MARK	DATE	DESCRIPTIONS	BY	CH'D	CCO#
0	03/08/10	MEP INTEGRATION	JE	SYC	110

CONTRACT CHANGE ORDER NO._____
SHEET _____ OF _____

DETAILS
SCADA REMOTE TERMINAL UNIT SYSTEM COMMUNICATION TERMINAL BOX WIRING DIAGRAM

E-959

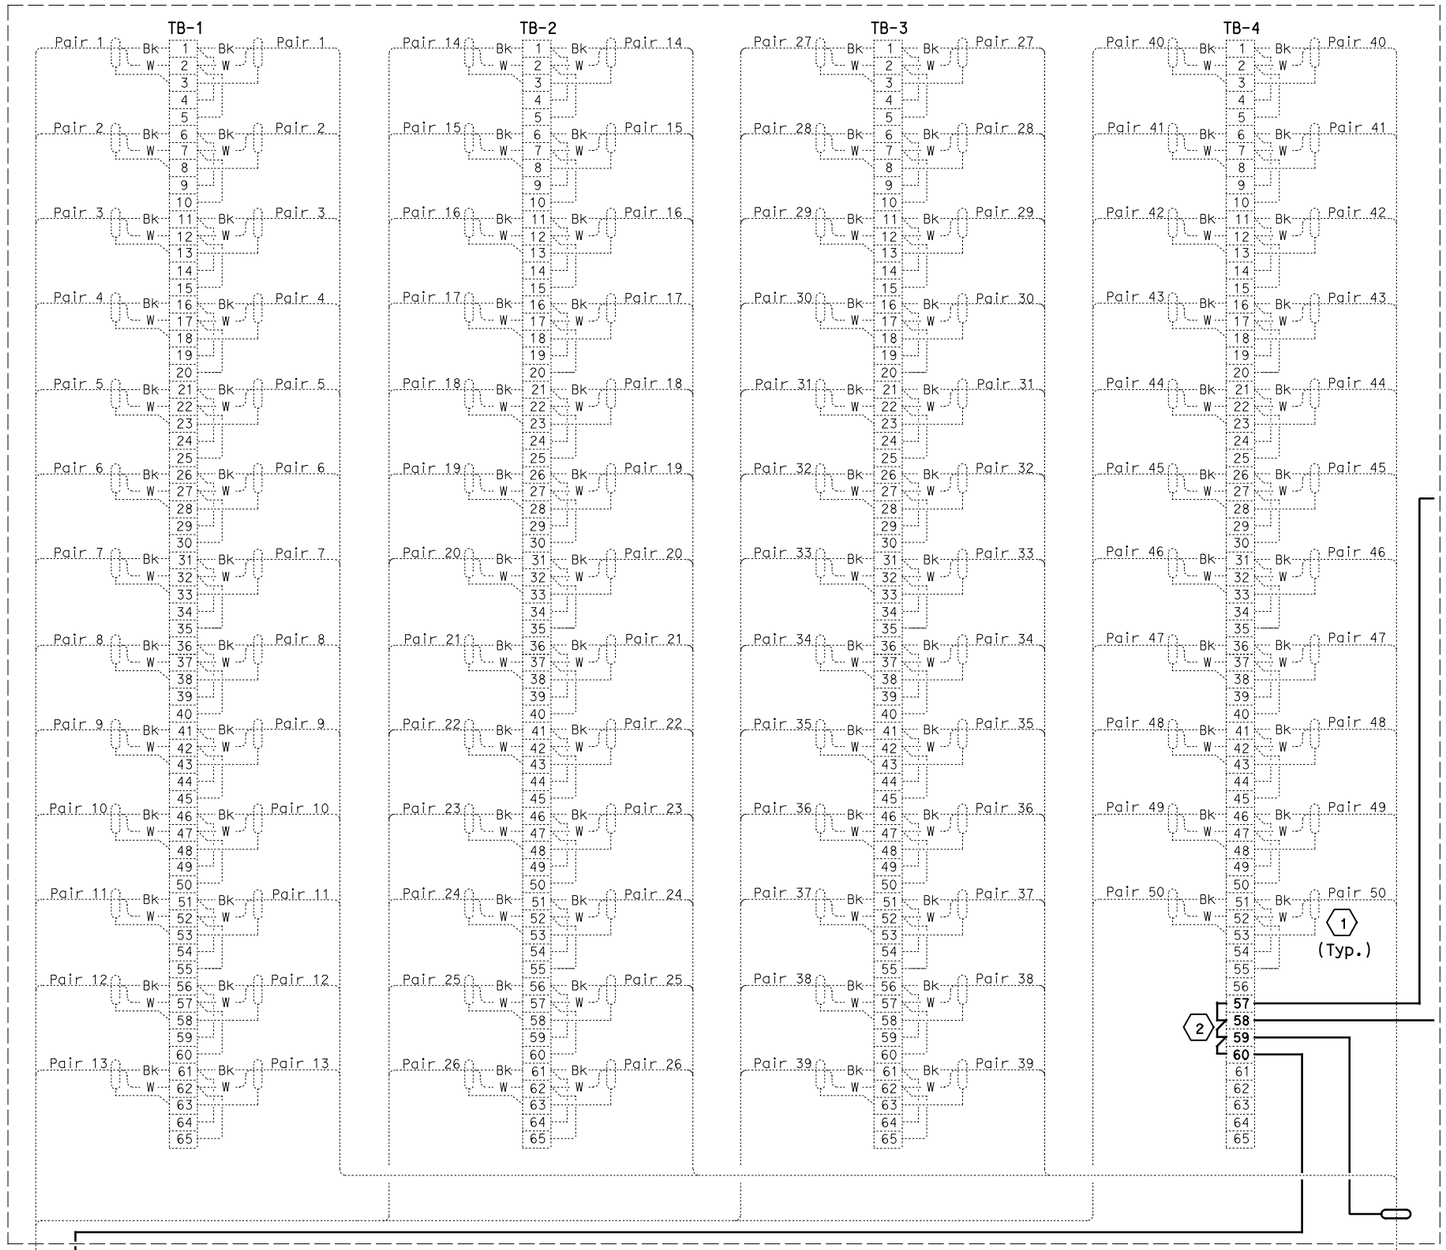
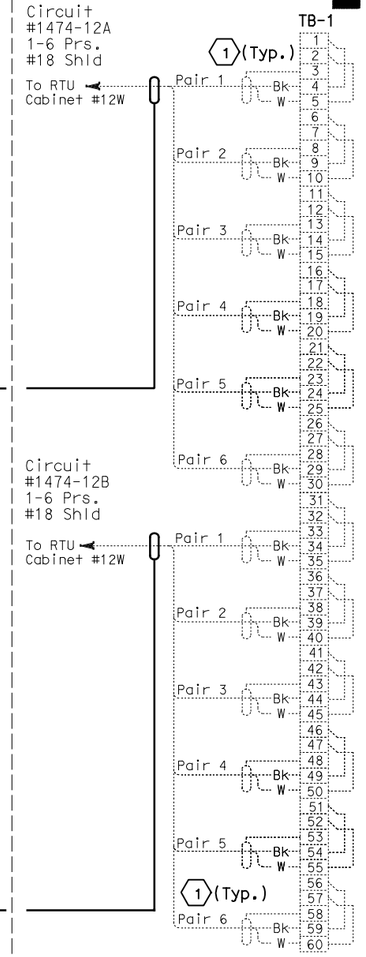
1. This plan sheet is a record drawing of the Skyway Structures SCADA Communications COM-09W and RTU Terminal Box #12W. The Contractor shall verify the existing installation. See sheet EE-372 from the Skyway Structures, contract No. 04-012024.

2. Contractor shall wire connection shown by bold lines.

(1) Verify that the shield is that not grounded.

(2) Do not ground shield.
